SERVICE BULLETIN

No. 693

Subject: Engine Baffle Seals Inspection/Modification

PA-31, 31-325, 31-300 Navajo
PA-31-350 Chieftain

SKETCH 1

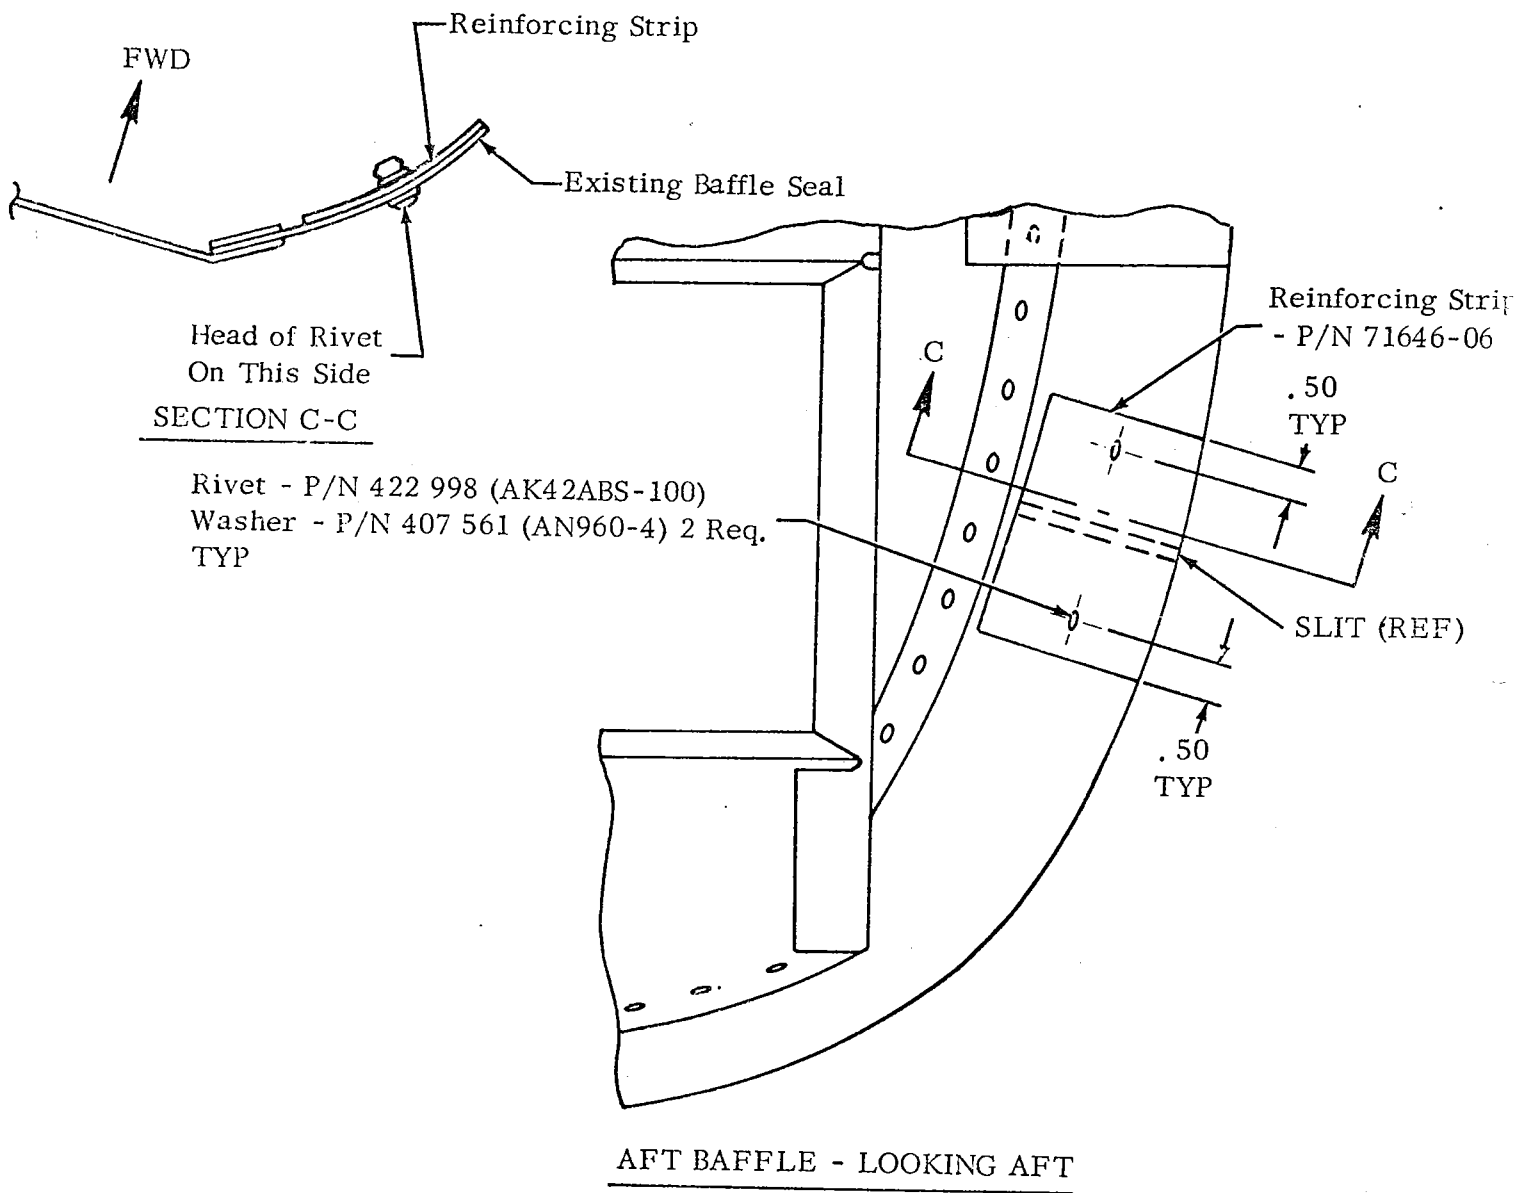
5. Install pop rivets Part Number 422 998 and AN960-4 washers, Part Number 407 561, with head of rivets on outside of seals. See Sketch 1.
6. Bond reinforcing strips Part Number 71646-06 to rear baffle seals at each slit with adhesive as described above.

SKETCH 2

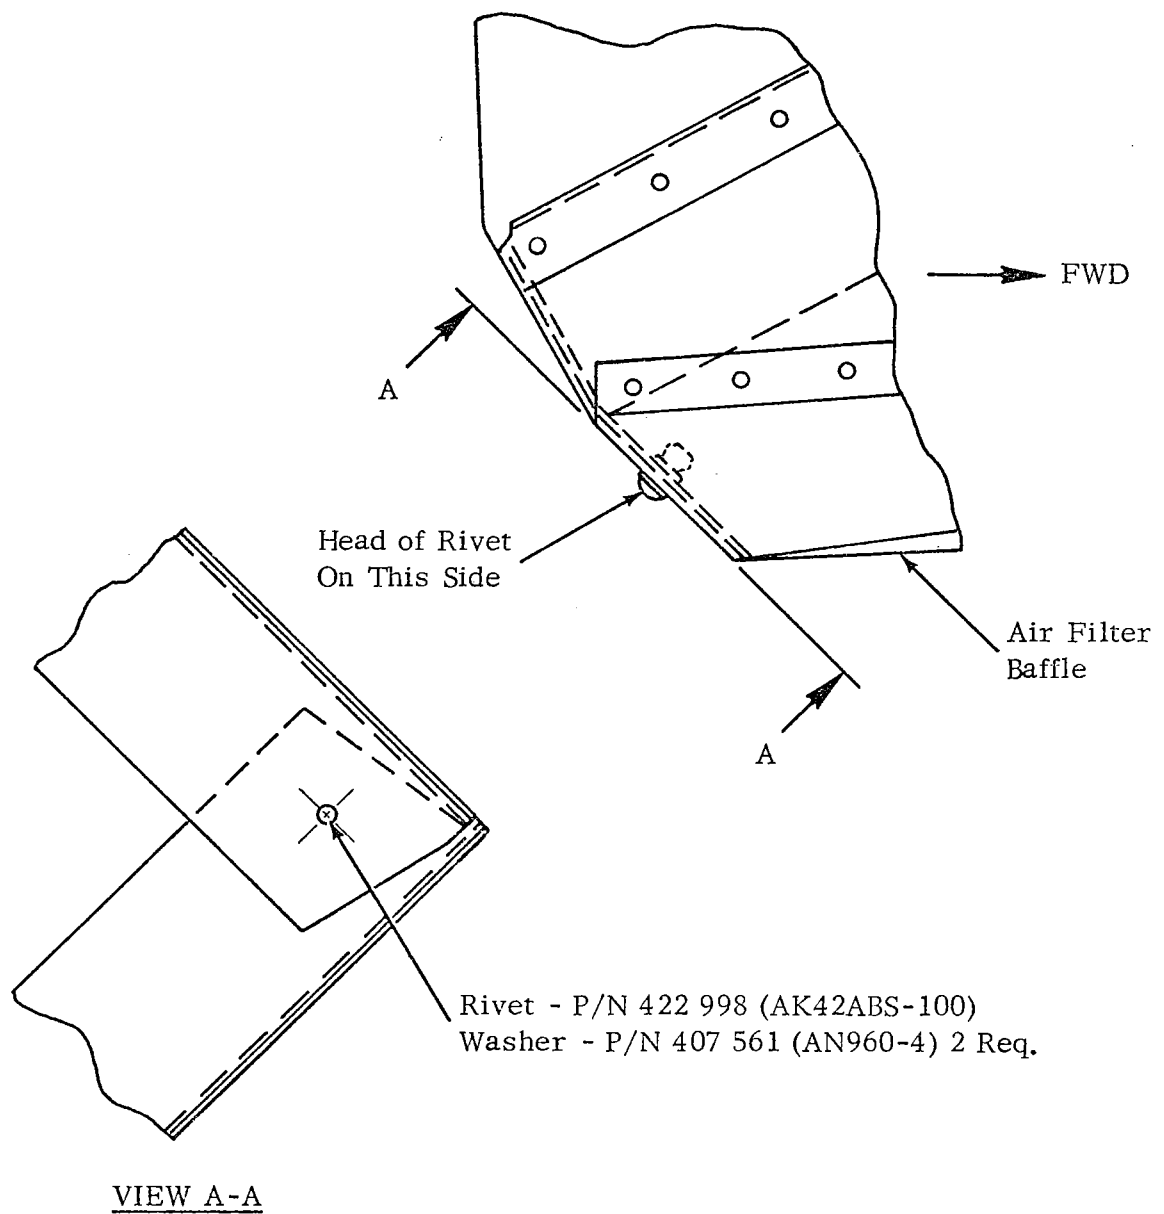
7. Install pop rivets Part Number 422 998 and AN960-4 washers, Part Number 407 561 as required per Sketch 2.
8. Insuring baffle seals are cleaned with MEK at rear of air filter, bond the overlapping corners with adhesive as described above.
9. Install one pop rivet Part Number 422 998 and one AN960-4 washer, Part Number 407 561 at each overlap area per Sketch 3.
10. Install cowling. Insure all baffle seals are facing forward.
11. Make appropriate logbook entry of compliance with this Service Release.
